**PLANNED UNIT DEVELOPMENT &  
SUBDIVISION STAFF REPORT**

**DEVELOPMENT NAME** Heron Lakes Subdivision, Phase 1, Lot 70,  
Resubdivision of

**LOCATION** 4106 Yellow Heron Lane  
(West side of Yellow Heron Lane, 125'+ South of  
Heron Lakes Circle)

APPLICATION NUMBER 47 & 48 DATE December 6, 2007

# SITE PLAN

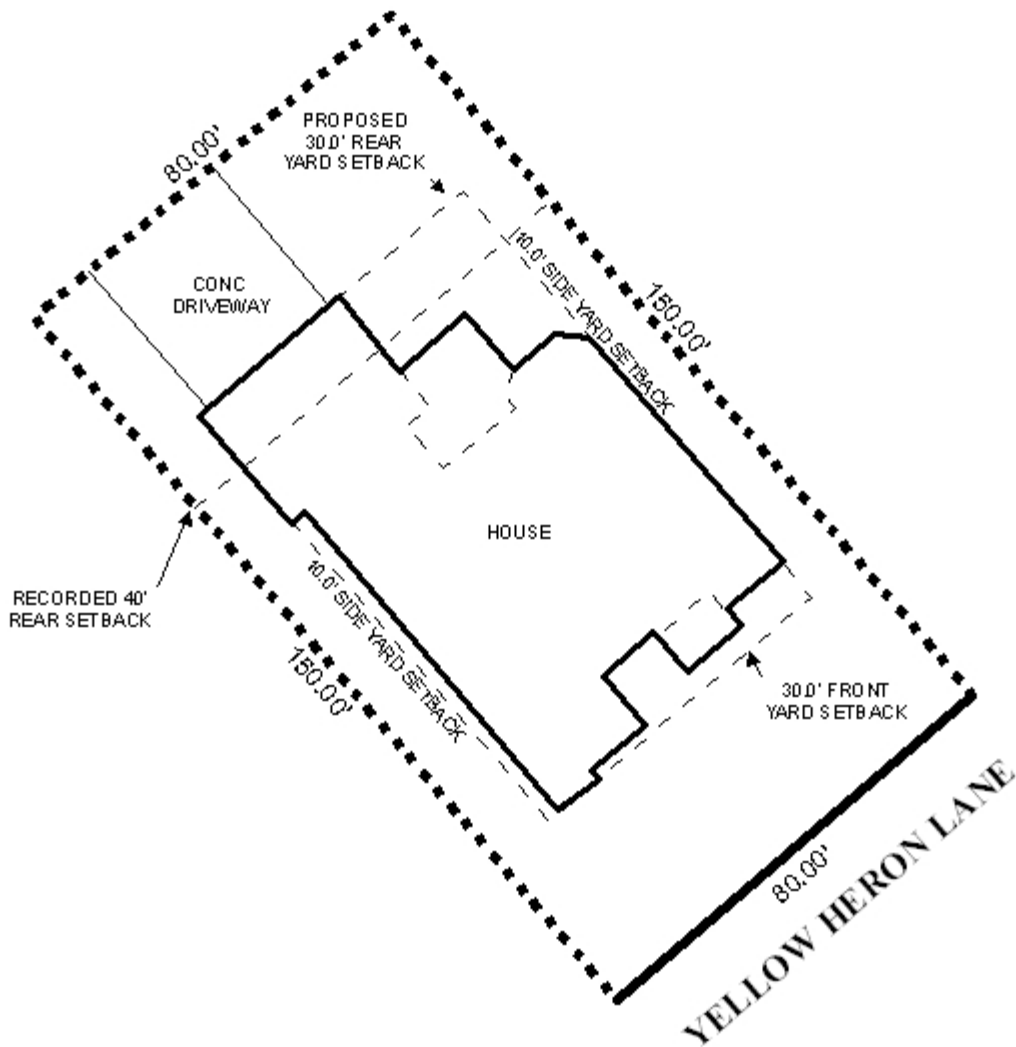
**ENGINEERING  
COMMENTS** Any increase in the original site coverage, will  
require the engineer to analyze that sufficient detention capacity exists for the increase in  
impervious area. It is the responsibility of the applicant to look up the site in the City of  
Mobile (COM) GIS system and verify if NWI wetlands are depicted on the site. If the  
COM GIS shows wetlands on the site, it is the responsibility of the applicant to confirm  
or deny the existence of wetlands on-site. If wetlands are present, they should be  
depicted on plans and/or plat, and no work/disturbance can be performed without a  
permit from the Corps of Engineers. Must comply with all storm water and flood control  
ordinances. Any work performed in the right of way will require a right of way permit.

The applicant is requesting an amendment to the existing PUD to allow increased site coverage to 38% and to modify the previously approved rear setback from 40' to 30'. The subject site was submitted for the same considerations and approved at the March 1, 2007 Commission meeting; however, the application erroneously stated Lot 80, which is across Yellow Heron Lane. To ensure considerations for the proper lot, this corrected application is now before the Commission.

Given the number of such requests and approvals, documentation should again be provided that the existing storm water system is adequate.

- 1) submission of documentation that the existing storm water facilities are adequate to handle the increased site coverage (including all previously approved increases), to be approved by City Engineering Department prior to signing of the final plat;
- 2) labeling of the plat to indicate the lot size in square or the provision of a table on the plat furnishing the same information; and
- 3) the placement of a note on the final plat stating that the site is allowed 38% maximum site coverage.

- 1) submission of documentation that the existing storm water facilities are adequate to handle the increased site coverage (including all previously approved increases), to be approved by City Engineering Department prior to signing of the final plat.
